Access Compliance Report

Public Rights-of-Way

Intersection ID: 19934	Main Street: W_ARROWWOOD_RD	Cross Street: WHITEHALL_EXECUTIVE_CENTER_DR	Location: NE
ADA ID: EBF936951F2A	Ramp Type: Perp	Initial Pass/Fail: Fail	Overall Compliance: No
Severity Score: 33.75			
Codes/Mitigation Info/Possible Solution		Field Measurements/Component Compliance

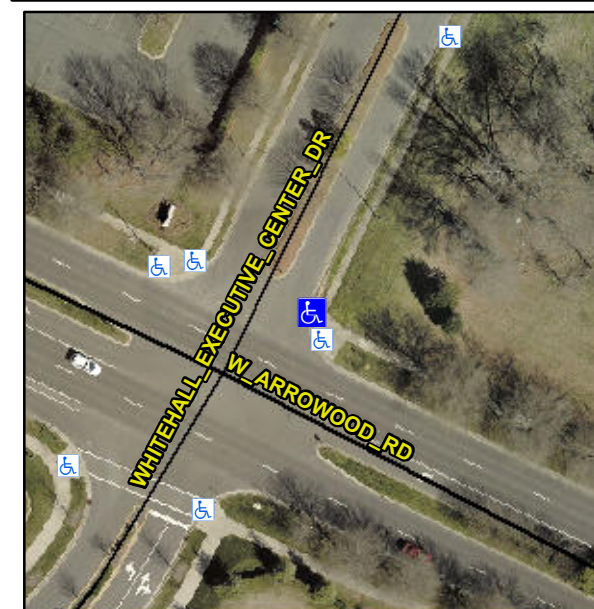
Not Found, R304.5.1, R304.2.2, R304.5.3

Compliance	Description	Data	Compliance	Description	Data
N/A	Ramp Length (in)	72.0	No	Ramp Slope (%)	11.0
No	Ramp Width (in)	45.5	No	Ramp XSlope (%)	5.4
N/A	Flare Type LT	N/A	N/A	Flare Type RT	N/A
N/A	Flare Slope LT (%)	N/A	N/A	Flare Slope RT (%)	N/A
N/A	Flare Traversable LT?	N/A	N/A	Flare Traversable RT?	N/A
N/A	Landing Length (in)	N/A	N/A	DWS Provided?	N/A
N/A	Landing Width (in)	N/A	N/A	DWS Contrast?	N/A
N/A	Landing Slope (%)	N/A	N/A	DWS Length (in)	N/A
N/A	Landing X Slope (%)	N/A	N/A	DWS Full Width?	N/A
N/A	Landing Curb? (Y/N)	N/A	N/A	DWS Offset (in)	N/A
N/A	Shared Landing?	N/A			
N/A	Gutter Ponding?	N/A	N/A	Gutter Slope (%)	N/A
N/A	Gutter Lip Ht (in)	N/A	N/A	Gutter X Slope (%)	N/A
N/A	Painted X Walk1?	No	N/A	Painted X Walk2?	N/A
	X Walk 1 Direction	To NW		X Walk 2 Direction	N/A
N/A	X Walk 1 Width (in)	N/A	N/A	X Walk 2 Width (in)	N/A
	X Walk 1 Slope (%)	3.4		X Walk 2 Slope (%)	N/A
	X Walk 1 X Slope (%)	7.2		X Walk 2 X Slope (%)	N/A

Remove & Replace Entire Ramp.
